ADDENDUM No. 7
TO
CITY OF FRESNO
PUBLIC WORKS STANDARD SPECIFICATIONS
ADOPTED MARCH 4, 1970
RESOLUTION NO. 70-36
UPDATED VERSION APPROVED: DECEMBER 2020 (tentative)
ADMINISTRATIVE DRAFT
for industry review and comment

This addendum is attached to, and made a part of, the above-entitled standard specifications.

The following City Standard Drawings have been amended as indicated below:

CITY OF FRESNO
P-29

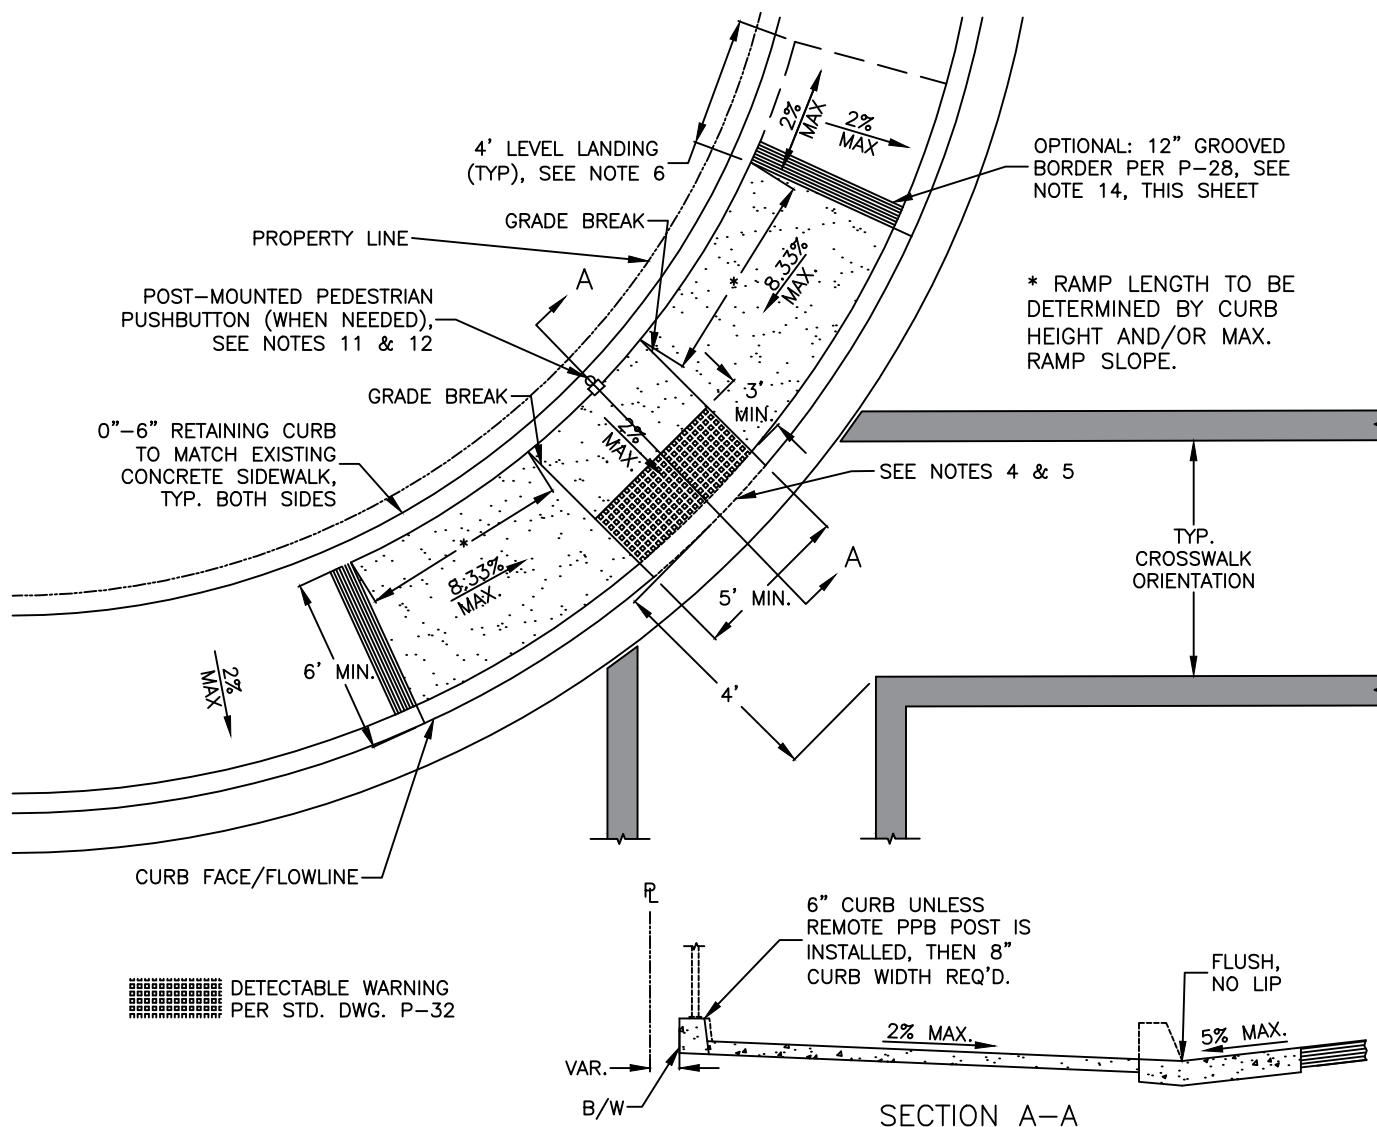
P-29	<ol style="list-style-type: none"> 1. Created alternate detail (Detail B) for condition when landing at bottom of ramp exceeds 5’-0”. 2. Added Note 1, updated numbering for Notes 2 through 5. 3. Note 3 (was note 2) revised to comply with MUTCD and accommodate new Detail B. 4. Added Note 10 regarding optional 12” grooved border. 5. Added (optional) grooved border to details. 6. Modified the following callouts: <ol style="list-style-type: none"> a. “TAPER CURB FROM 6” TO ½” BEVEL” Revised to read: “TAPER CURB FROM 6” TO FLUSH”. b. “2% MAX. SLOPE DETECTABLE WARNING DEVICES REQUIRED SEE P-32” Revised to read: “DETECTABLE WARNING DEVICES PER CITY STD. DWG. P-32”. c. “NOTE: SLOPE 5% MAX ON GUTTER IN RAMP AREA” Revised to: “SLOPE 5% MAX IN GUTTER AND ADJACENT PAVING IN RAMP AREA” d. “6” WIDE RETAINING CURB WITH VARIABLE HEIGHT” Revised to: “RETAINING CURB: 0”-6” 7. Deleted the following callouts and dimensions: <ol style="list-style-type: none"> a. “6” STANDARD CURB” b. “4’ WALK MIN.” c. “8’ MIN.” d. “10% MAX CROSS SLOPE” e. “8.33% MAX SLOPE” f. “MEET TOP OF CURB” 8. Added depiction of level-landing at top of ramp as required by Note 6.

P-70

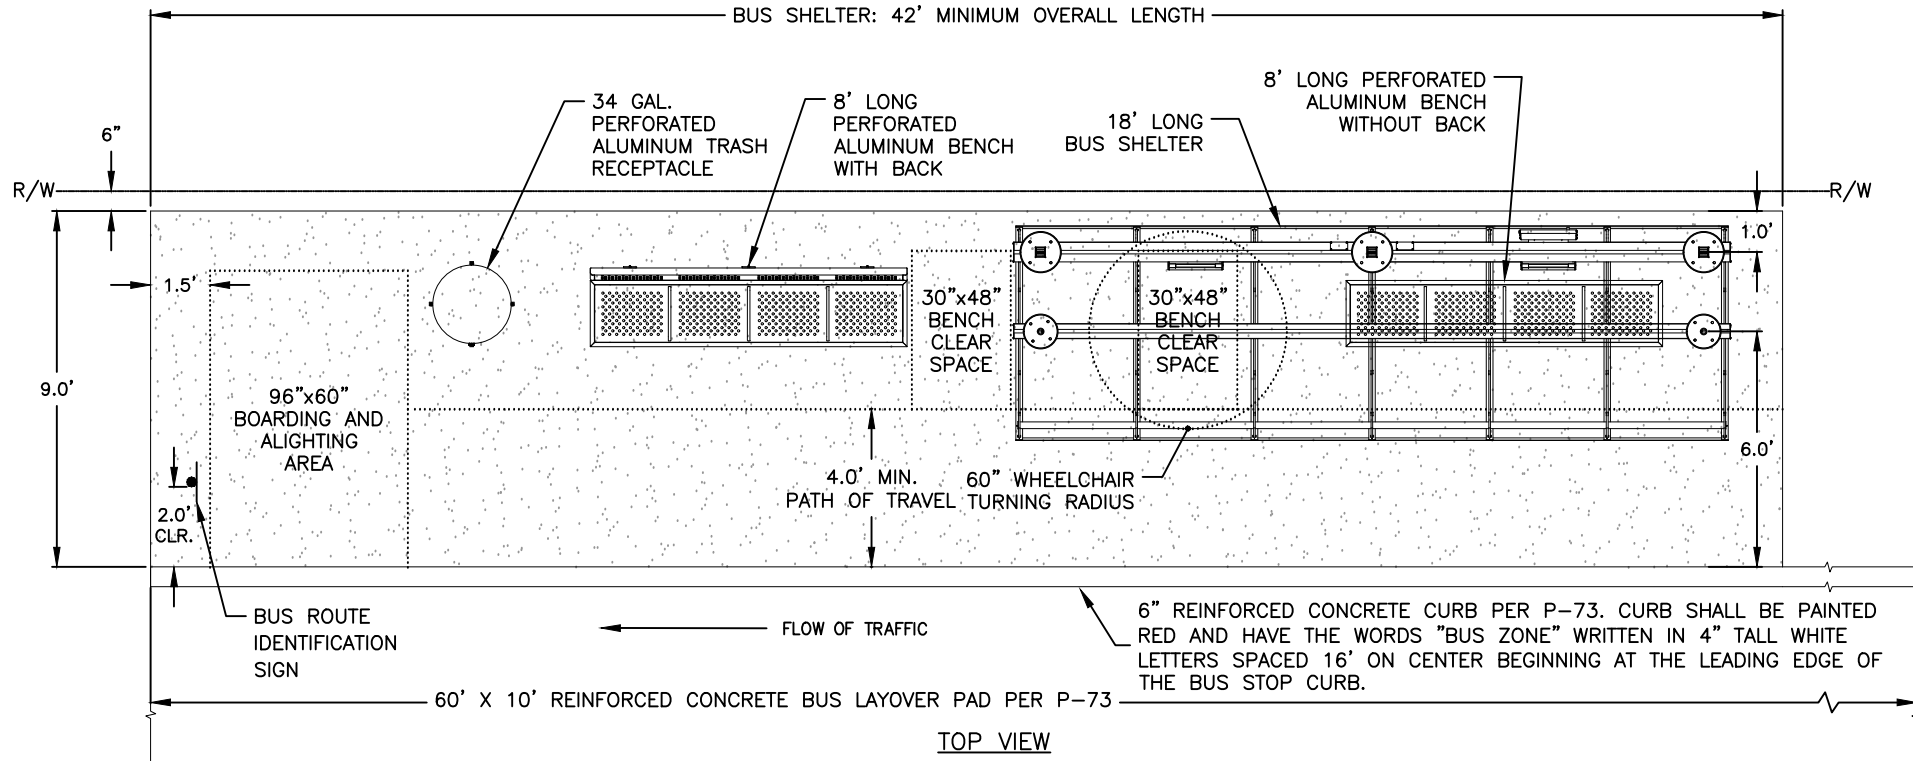
P-70	5. Added Note 6: requires developer / engineer to prepare and submit truck-turning simulation when opposing dual-lefts are proposed at a new or existing intersection.
P-72	1. Drawing title: “BUS SHELTER ELECTRICAL LAYOUT” Revised to read: “BUS STOP WITH SHELTER LAYOUT” 2. All references to electrical conduits and related equipment have been removed. 3. A number of new bus stop appurtenances and furniture have been added to the detail including significant dimensional changes
P-73	1. Dimension: “FAR SIDE INTERSECTION” (8”) Revised to read: “ 8’ ”.
P-79	1. Existing NOTES have been numbered. 2. References to minimum bike lane widths changed to 6’ when adjacent to on-street parking. 3. Note 1: “TO THE GREATEST EXTENT POSSIBLE, CASE I BIKE LANES WILL BE INSTALLED. CONSIDERATION WILL BE GIVEN TO 5-FOOT BIKE LANES (MEASURED FROM FACE OF CURB),

CITY OF FRESNO
S-13A

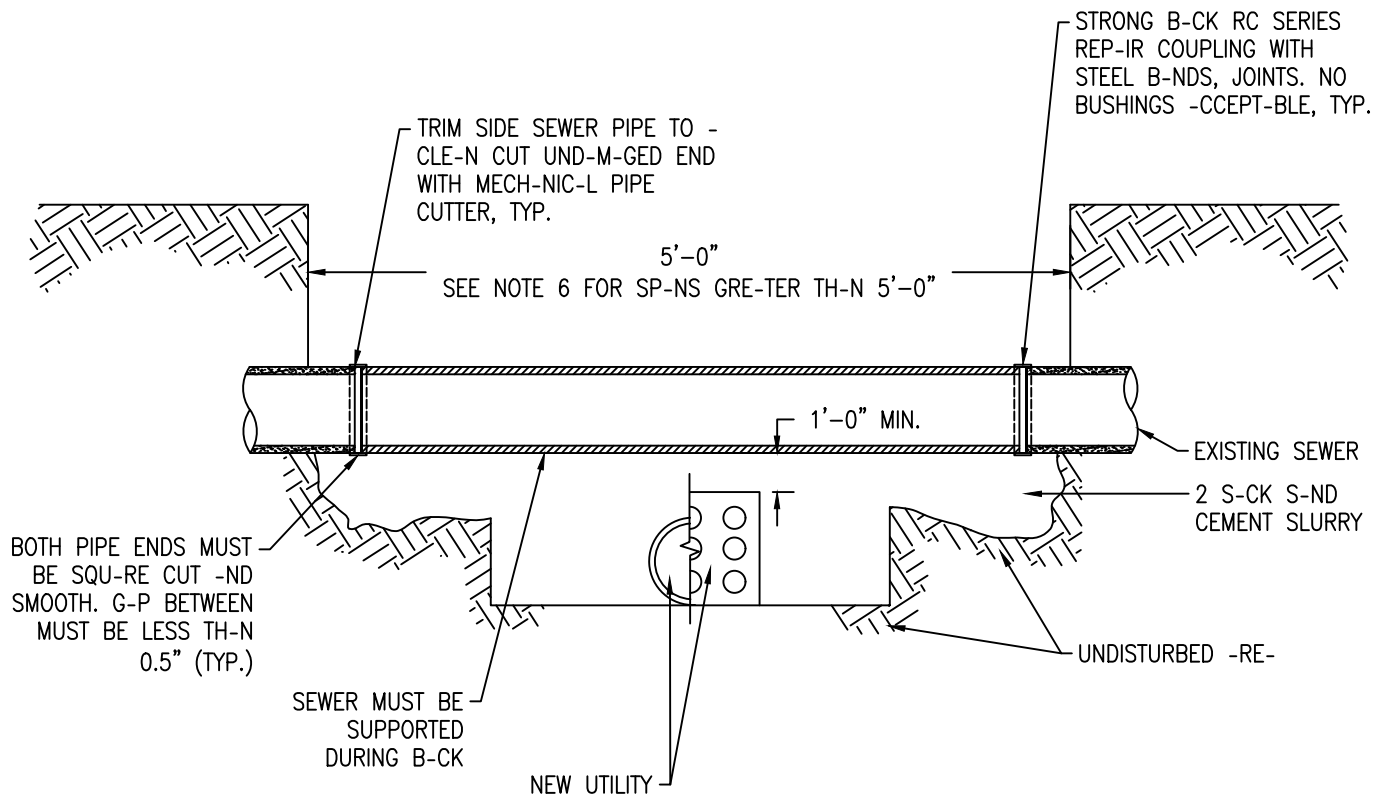
S-10	<ol style="list-style-type: none"> 1. Added callouts and updated hatching for "Paved" and "Unpaved" surface conditions. 2. Minor edits to detail and callouts for clarity.
S-13A	<ol style="list-style-type: none"> 1. New Standard Drawing: "PIPE/CONDUIT CROSSING UNDER EXISTING SEWER - CASE 1"
S-13B	<ol style="list-style-type: none"> 1. New Standard Drawing: "PIPE/CONDUIT CROSSING UNDER EXISTING SEWER - CASE 2"
